Subject: MHI's Response to US-APWR DCD RAI No. 498-3782

Response to Request for Additional Information No. 498-3782,
Revision 0 (45-day response)

US-APWR Design Certification

SRP SECTION: 03.09.02 - Dynamic Testing and Analysis of Systems Structures and Components

Figure 1 Stick Mass Spring Model for Reactor Coolant Loop

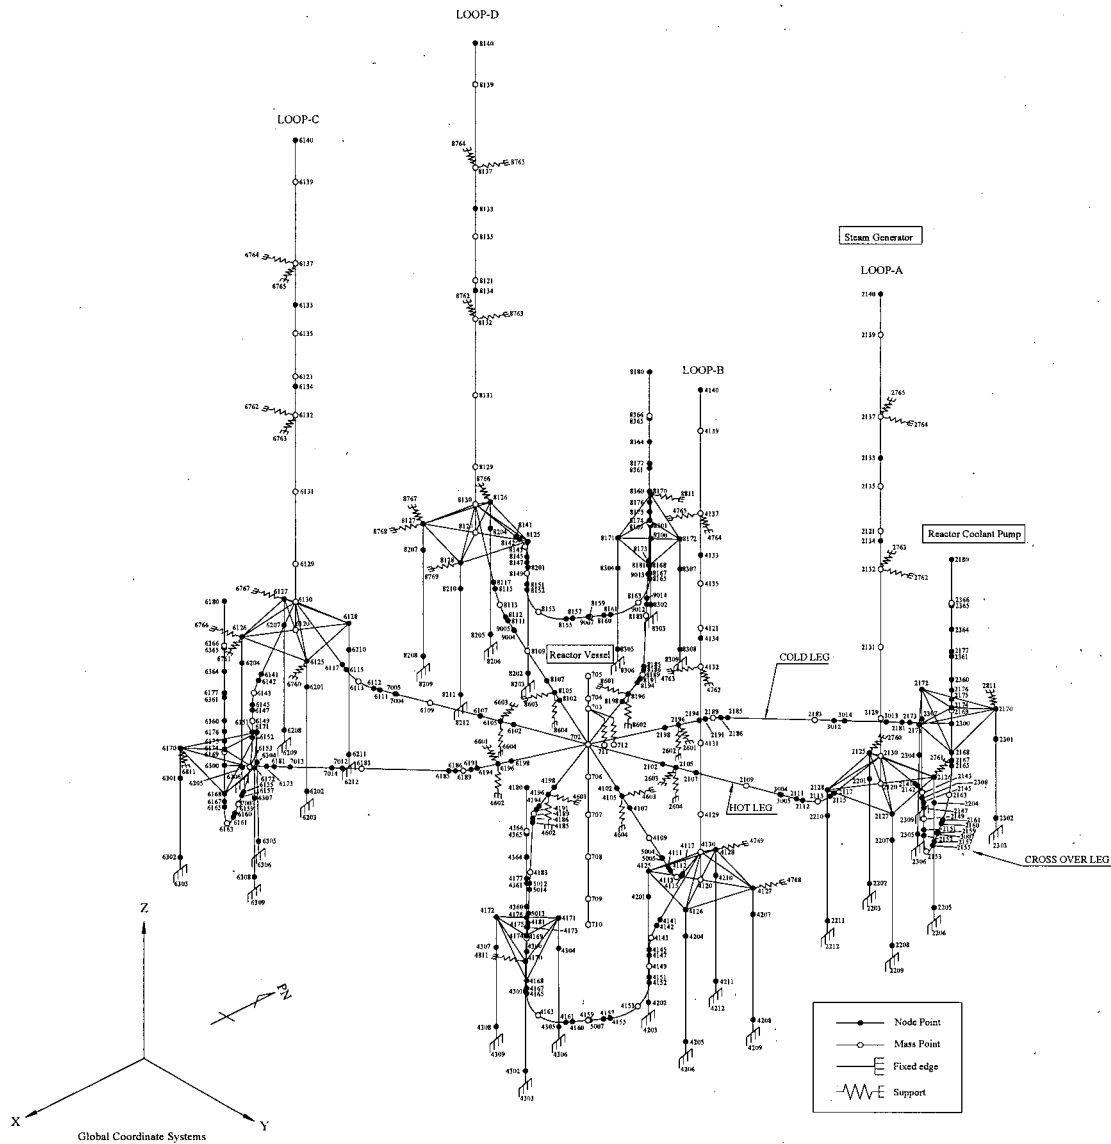
- (a) Provide a description of how the steam generator (SG) shell flexibility was considered in the analysis in the vicinity of piping nozzle penetrations.
- (b) Provide a description of how the decoupling criteria in SRP 3.7.2 SRP Acceptance Criteria II.3.B was considered and applied to justify the analysis of the upper internal structure separately from the SG shell model. If any deviations were made from the SRP 3.7.2 criteria provide the rationale for such deviations.

- (a) Local flexibility of the SG shell at the primary nozzle connections is considered as a six degrees of freedom spring connecting between the end node of Hot Leg elbow and the tip node of SG inlet nozzle, and between the tip node of SG outlet nozzle and the node of outlet elbow of Cross Over Leg, in the whole stick mass spring model for the Reactor Coolant Loop as shown in Figure 1 of Technical Report MUAP-08005, Rev. 0.
